STAFF RECOMMENDATION
924B South Douglas Avenue
October 21, 2020

Application: New Construction—Outbuilding
District: Waverly-Belmont Neighborhood Conservation Zoning Overlay
Council District: 07
Map and Parcel Number: 105130F00200CO
Applicant: Troy Harper
Project Lead: Melissa Sajid, melissa.sajid@nashville.gov

<p>Description of Project: Application is to construct an outbuilding. The outbuilding will not include a dwelling unit.</p> <p>Recommendation Summary: Staff recommends disapproval of the project, finding that the proposed outbuilding does not meet Section III.H.1.b (footprint) of the design guidelines for the Waverly-Belmont Neighborhood Conservation Zoning Overlay.</p>	<p>Attachments A: Site Plan B: Elevations</p>
---	--

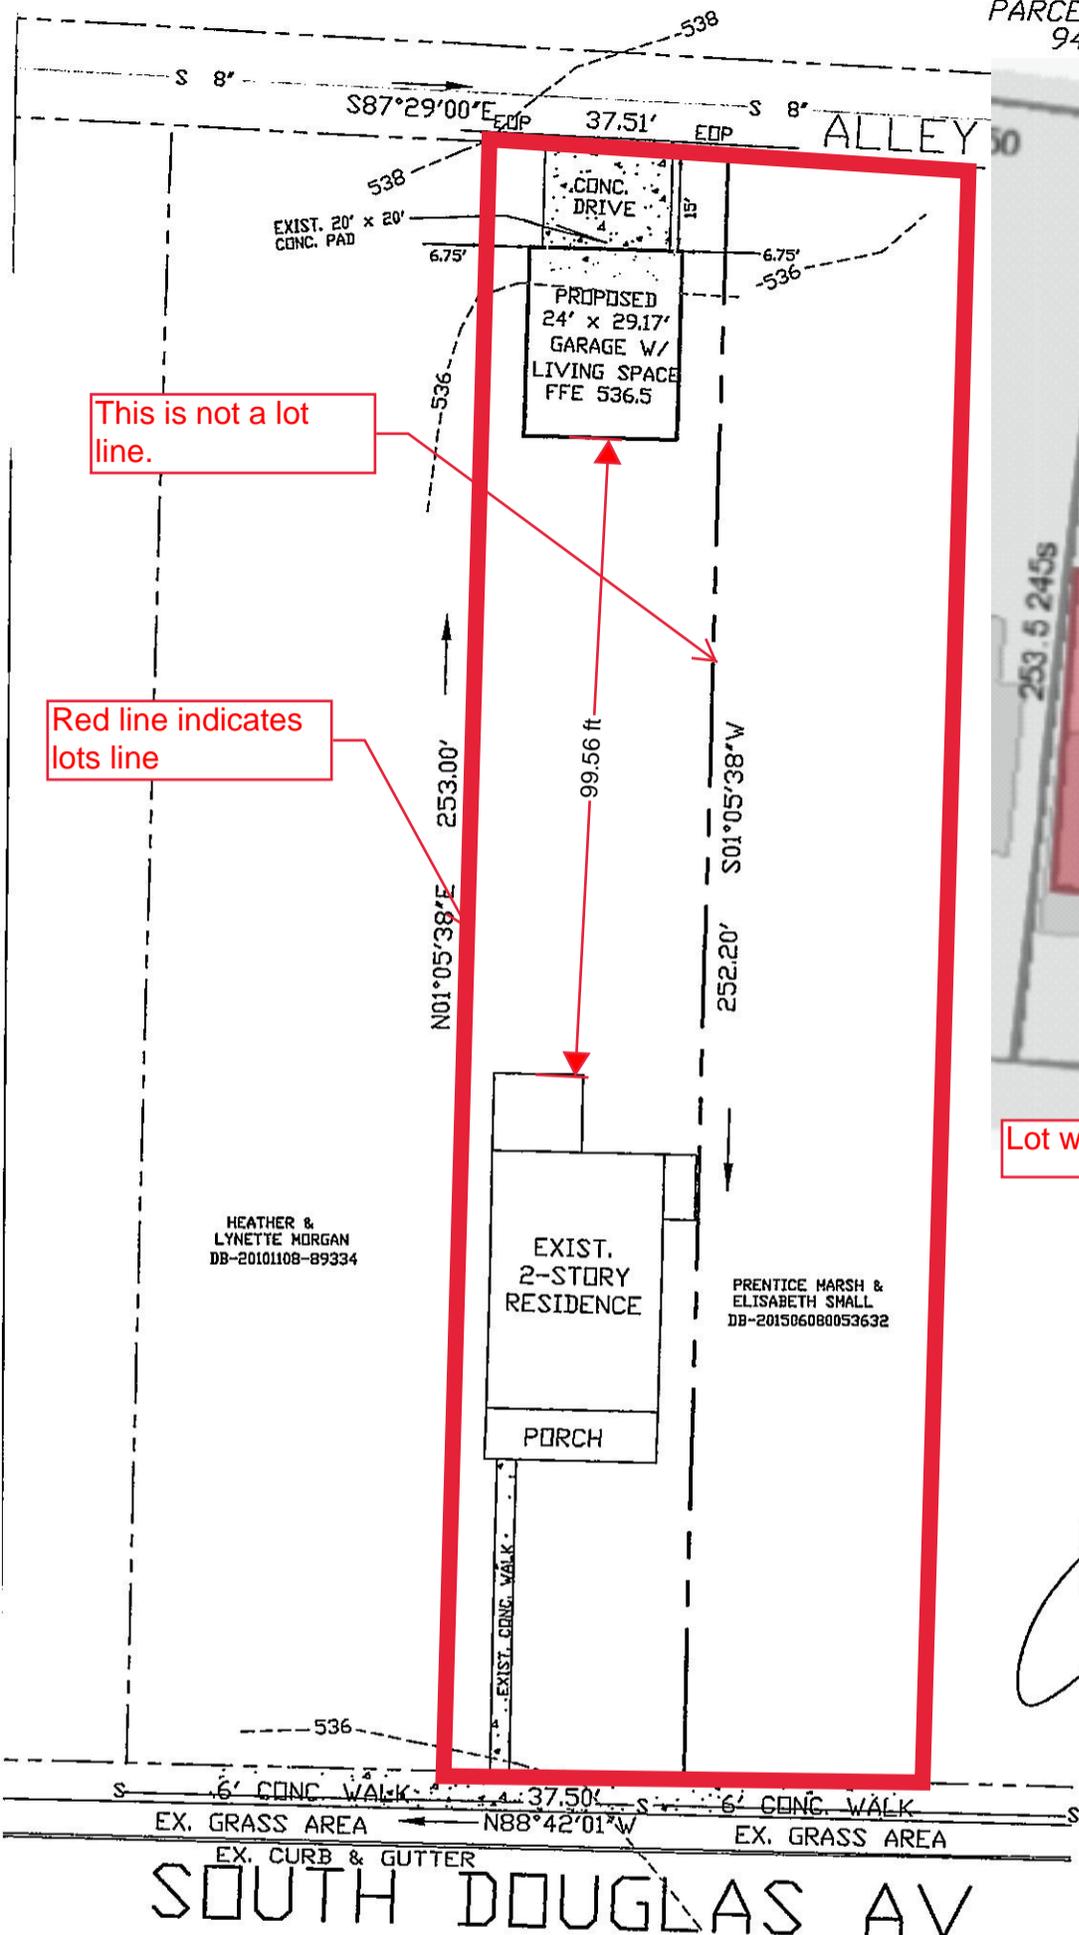
YES	NO
If there are stairs, are they enclosed?	X	
If a corner lot, are the design and materials similar to the principle building?	N/A	N/A
If dormers are used, do they cover less than 50% of the roof plane where they are located as measured from side-to-side?	N/A	N/A
If dormers are used, do they sit back from the wall below by at least 2'?	N/A	N/A
Is the roof pitch at least 4/12?	X	
If the building is two-bay and the vehicular doors face the street, are there two different doors rather than one large door?	N/A	N/A
Is the building located towards the rear of the lot?	X

The outbuilding meets Sections III.H.3 and III.H.6 of the design guidelines.

924B SOUTH DOUGLAS AVE.

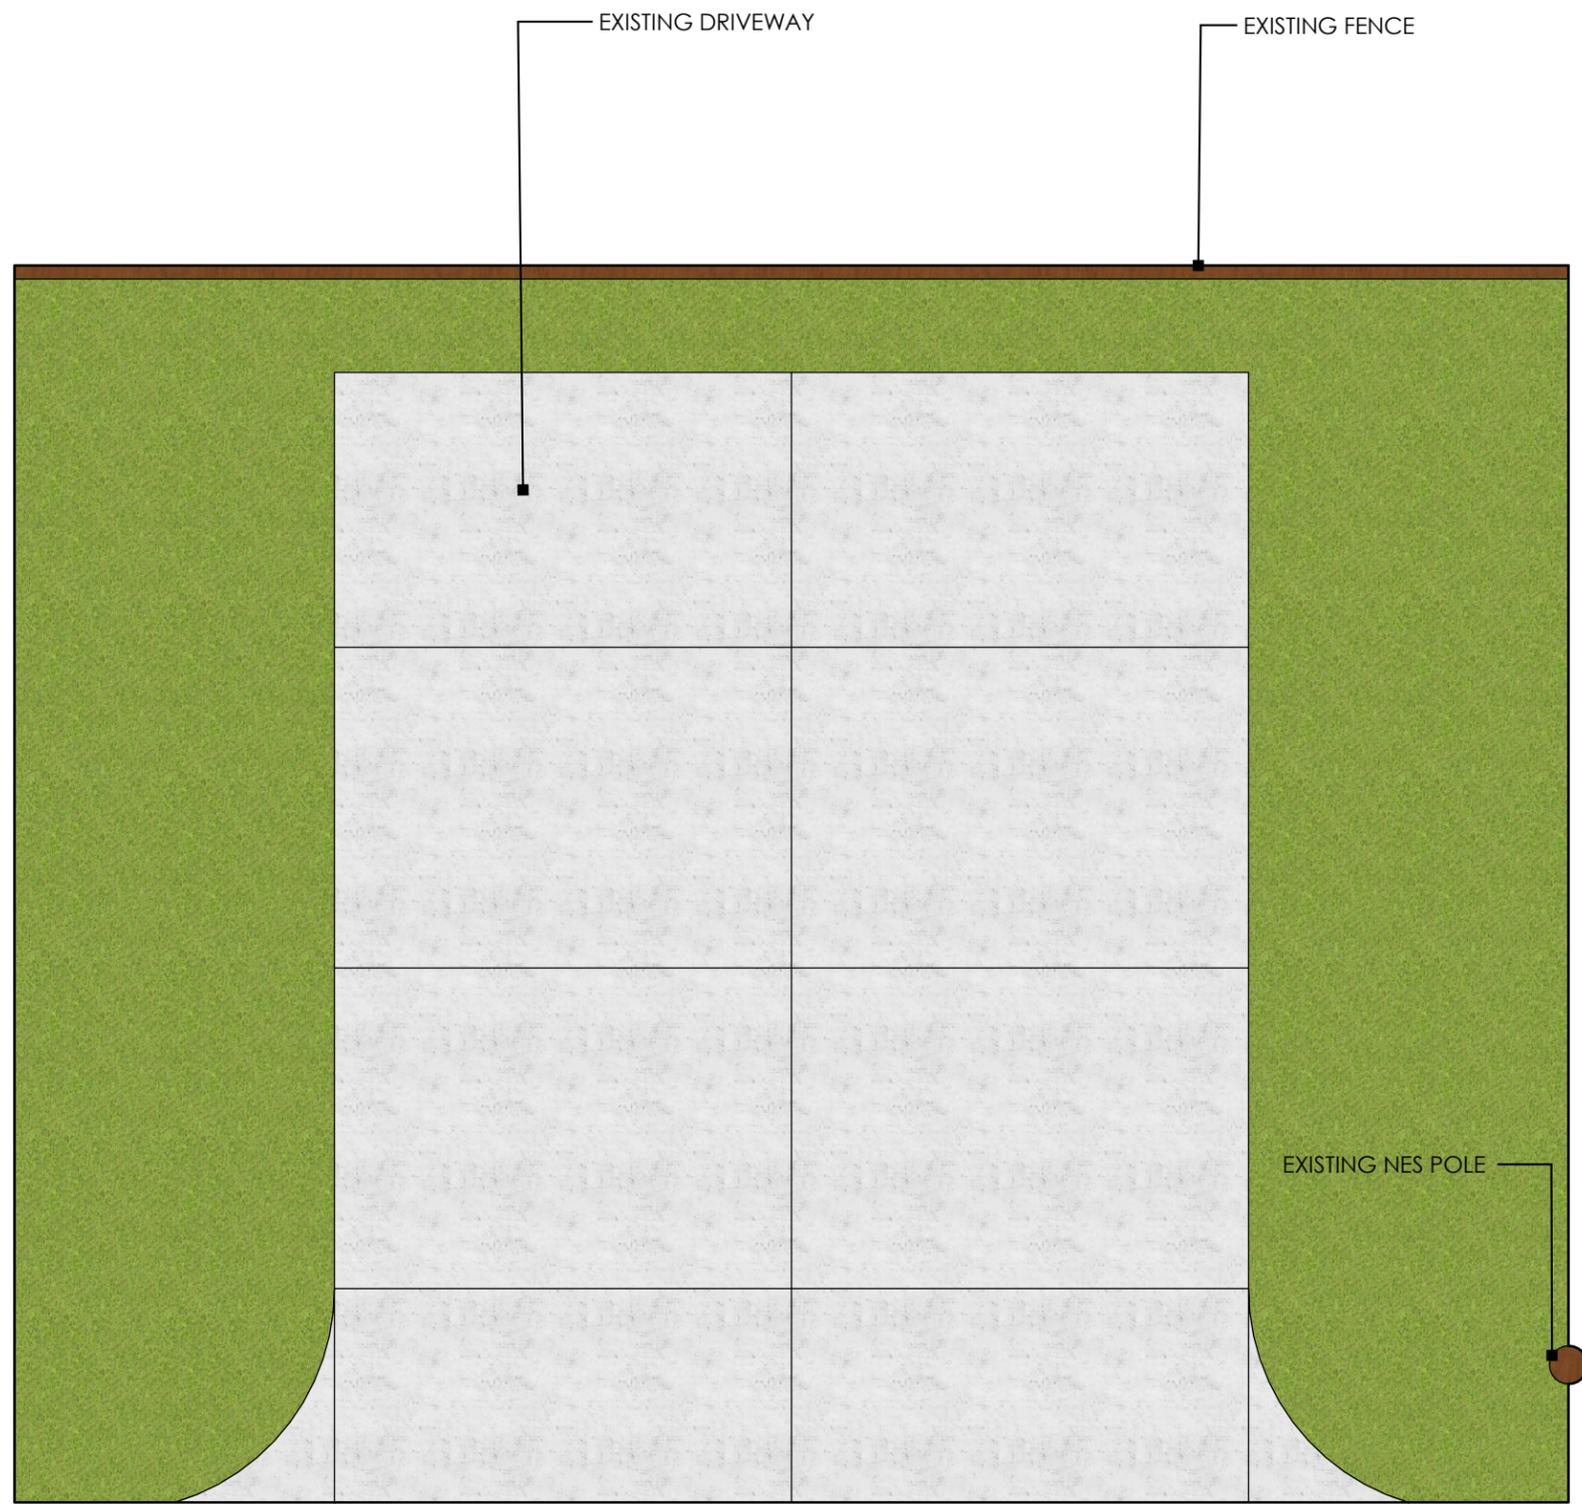
Since the lot is greater than ten thousand square feet (10,000 sq. ft.), the maximum footprint for outbuildings for the entire lot is one thousand square feet (1000 sq. ft.). Unit A already has an outbuilding with a footprint of six hundred seventy-two square feet (672 sq. ft.). The current proposal would add an outbuilding with a footprint of seven hundred square feet (700 sq. ft.), which would make the cumulative footprint one thousand three hundred seventy-two square feet (1372 sq. ft.). This exceeds the maximum permitted by the design guidelines by three hundred seventy-two square feet (372 sq. ft.). As

proposed, the addition of the proposed outbuilding does not meet Section III.H.1.b of the design guidelines. Staff is not recommending approval with a condition that the footprint be reduced to three-hundred and twenty-eight square feet (328 sq. ft), because that reduction would likely change the design enough that the Commission would not know what they are actually approving at this meeting.

MINIMUM	PROPOSED
Space between principal building and DADU/Garage	20'	~100'
Rear setback	5'	15'
L side setback	5'	6'-9"
R side setback	5'	6'-9"
How is the building accessed?	From the alley or existing curb cut	Alley

The proposed setbacks meet Sections III.H.6 of the design guidelines.
